Contract #: 04-0120F4Cty: SF/ALA Rte: 80 PM: 13.2/13.9File #: 69.25B**QUALITY ASSURANCE -- NON-CONFORMANCE REPORT****Location:** Changxing Island, Shanghai, PRC**Report No:** NCR-000412**Prime Contractor:** American Bridge/Fluor Enterprises, a JV**Date:** 21-Sep-2009**Submitting Contractor:** Zhenhua Port Machinery Company, Ltd (ZPMC), Changxing Island**NCR #:** ZPMC-0386**Type of problem:**

To:	AMERICAN BRIDGE/FLUOR, A JV 375 BURMA ROAD OAKLAND CA 95607	Date:	21-Sep-2009
Dear:	Mr. Charles Kanapicki	Contract No:	04-0120F4 04-SF-80-13.2 / 13.9
Attention:	Mr. Thomas Nilsson Project/Fabrication Manager	Job Name:	SAS Superstructure
Subject:	NCR No. ZPMC-0386	Document No:	05.03.06-000374

Reference Description: Missed Indication (MT) & Repair Without Engineer Approval / South Shaft Lift 3 / Base Metal / Transverse Indication

Picture of CT verification

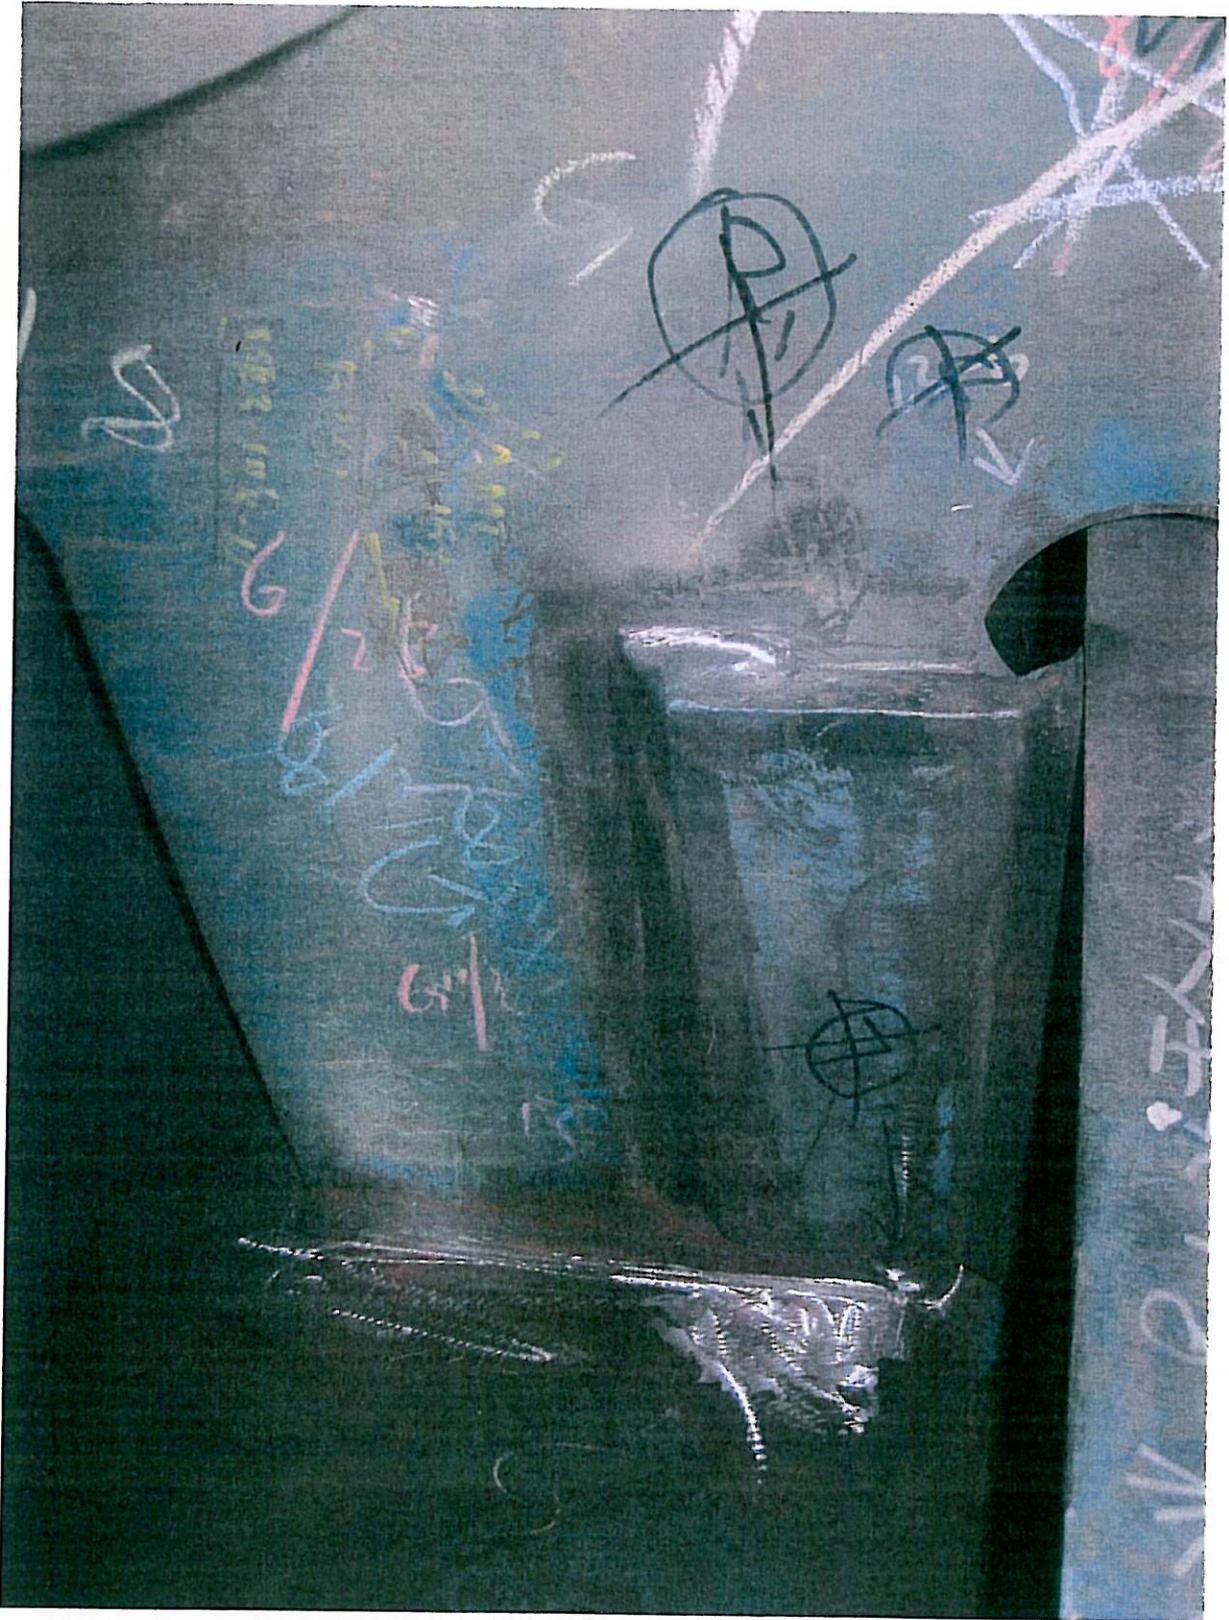
ZPMC received NCR-000412(ZPMC-0386), it mentioned QA discovered a 20mm long transverse linear indication in the base metal during MT of south tower, lift 3, 102.5m diaphragm to skin C weld SSTL3-1H/K-12.

During Magnetic Particle Testing (MT) of South Tower, Lift 3, 102.5 m Diaphragm to Skin C weld SSTL3-1H/K-12, QA discovered a 20mm long transverse linear indication in the base metal which was previously tested and accepted by ZPMC Quality Control personnel. ZPMC proceeded to excavated 3mm to 4mm deep to remove the base metal indication and repaired it without prior Engineer approval.

ZPMC acknowledged this. When ZPMC received this information, the grinder was arranged and the indication was removed from the weld surface. ZPMC MT technician and CT inspector retested the weld subsequently.

So ZPMC hope Caltrans could take a review and close this NCR basing on attached document.
